INDIANA COAL COUNCIL’S COMMENTS ON NIPSCO 2016 INTEGRATED RESOURCE PLAN

A. INTRODUCTION. The Indiana Coal Council (“ICC”) conducted a review of the Integrated Resource Plan (“IRP”) that Northern Indiana Public Service Company (“NIPSCO”) prepared and submitted to the Indiana Utility Regulatory Commission (“IURC”) on November 1, 2016. In response to the NIPSCO’s IRP, ICC submits the comments below.

Exhibit 2-2. PIRA FORECASTS FOR PRB AND ILB COAL⁷

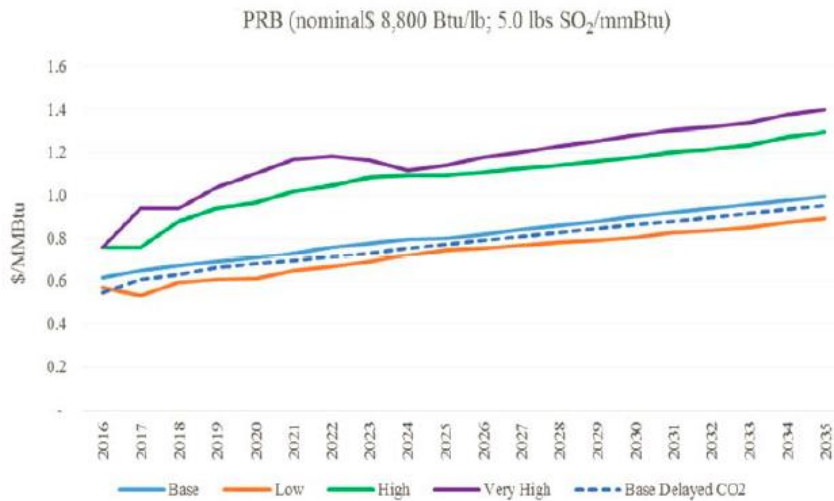
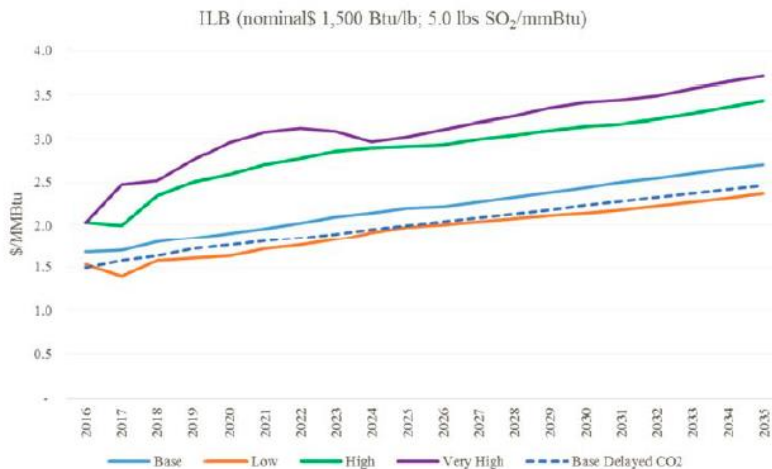
⁷ Both graphs have errors in their headers. Power River Basin should be Powder River Basin. PRB coal price is for a 0.5# SO₂ coal. ILB typically Btu/lb is 11,500.

Exhibit 2-4 HISTORICAL PRICES AND CORRELATIONS

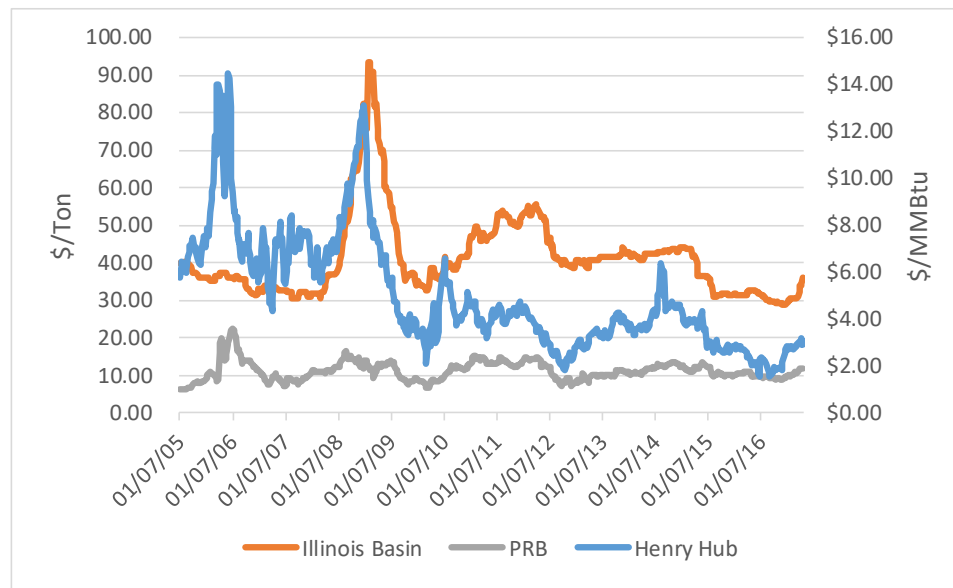
- 2.7 NIPSCO's use of a correlated price forecast between coal and gas prices is not explained. An analysis of historical prices shows that the Pearson's r coefficient between coal and gas prices is not statistically significant. Yet, an analysis of NIPSCO's forecast coal and gas prices shows that the Pearson's r coefficient between coal and gas is statistically significant. Historical prices and Pearson R's are shown in **Exhibit 2-4**

Exhibit 2-7. Comparison of EIA North Central NG Prices and PIRA Chicago City Gate Gas Prices (Nominal \$/MMBtu)

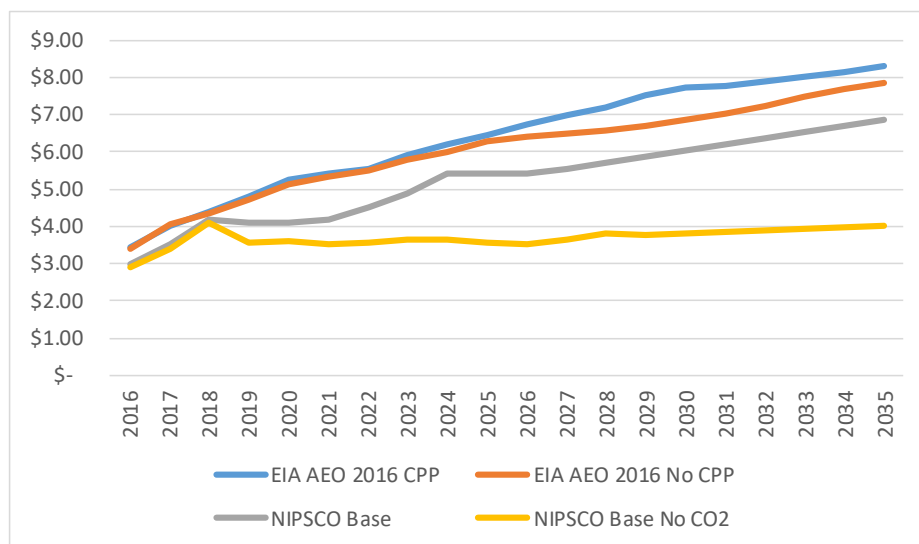
- 2.16 Just as NIPSCO did not validate any of its price forecasts, it also did not validate the differences between the carbon and no carbon gas price forecasts. The differential between the carbon and no carbon gas price forecasts is inconsistent with the forecasts produced by the EIA as part of the 2016 Annual Energy Outlook (AEO). As shown in **Exhibit 2-7** in the AEO the gas price forecast without carbon is also lower than the gas price forecast with carbon but by a much smaller amount. Further, the difference declines over time in contrast to the PIRA forecast in which they increase over time.

Exhibit 2-8 EVA Long-Term Natural Gas Price Forecast

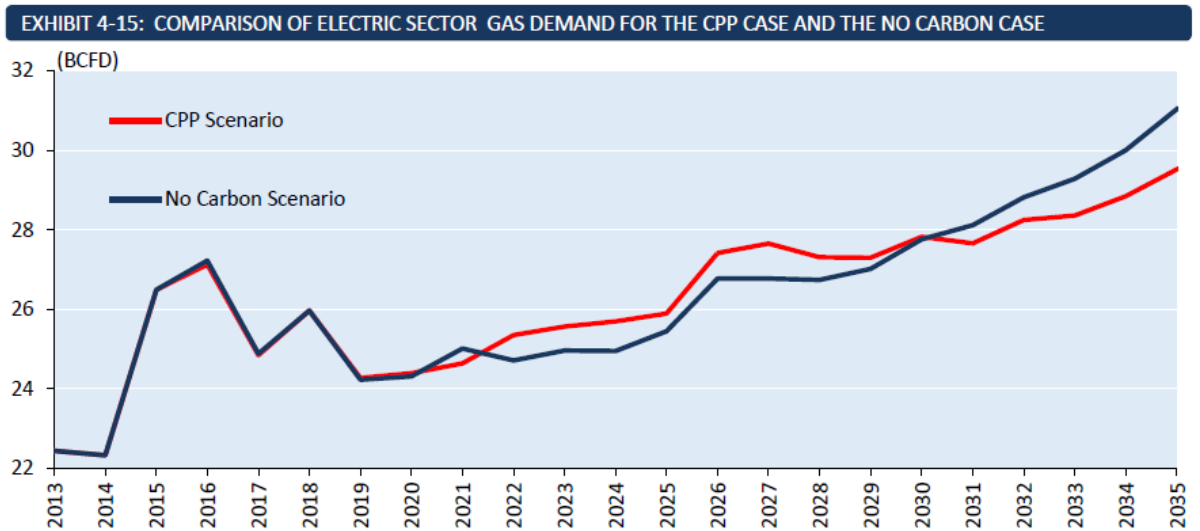
- 2.17 The differential is also inconsistent with published forecasts from ICC's consultant, Energy Ventures Analysis, Inc. (EVA). As shown in **Exhibit 2-8**, EVA's forecast with and without carbon are even closer than EIA's. Of note, EVA's natural gas price forecast without carbon moves higher than its forecast with carbon around 2033 because its modeling shows that under the Clean Power Plan a combination of factors including lower electricity demand, higher renewables, distributed generation, and higher nuclear generation reduce the demand for natural gas in the power sector around 2033.
